# Return Loss Comment

March 2006

- Comment submitted by D'Ambrosia
  - Return Loss Specification is insufficient

# Return Loss – SDD11

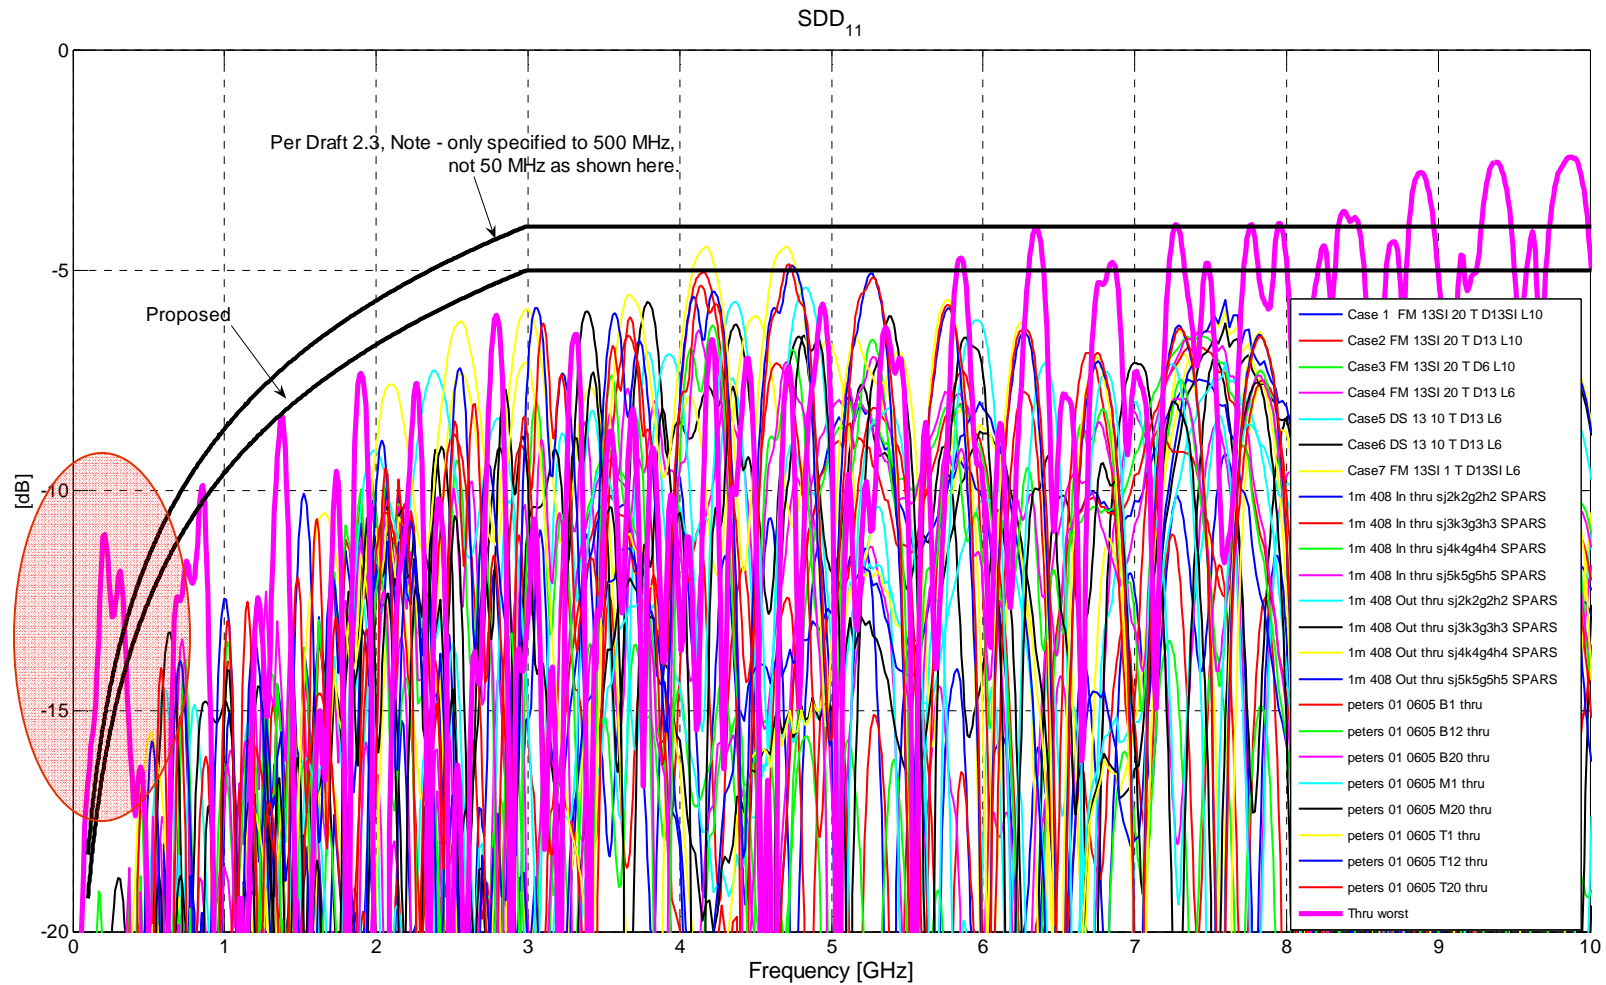
- Work based on “Thru-Worst” channel

- Change Equation 69B-12

- $RL(f) \geq RL_{\max}(f) = 22 - 9.56 * \log_{10}\left(\frac{f}{50\text{MHz}}\right)$

- Change frequency range for 69B-12 to

- For  $50\text{MHz} < f < 3000 \text{ MHz}$

- Change Equation 69B-13

- $RL(f) \geq RL_{\max}(f) = 5$

- Change frequency range for 69B-13

- For  $3000 \text{ MHz to } 10,312.5 \text{ MHz}$
